Item No.84 GEAR CHANGE STAY

JAVELIN

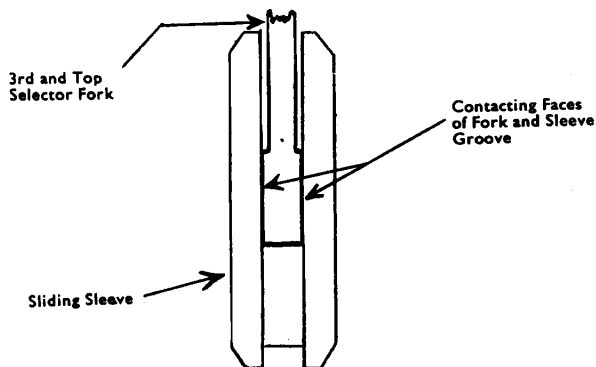
moved axially on the driving dog, thereby eliminating any tendency for the sliding sleeve to be incorrectly aligned when in full engagement with the gear dog teeth. The

increased width of the selector fork necessitates an increase in the width of the sliding sleeve groove, and the fork and sleeve are only interchangeable with the previous type in pairs.

For part change information please refer to Spares Note No. 92.
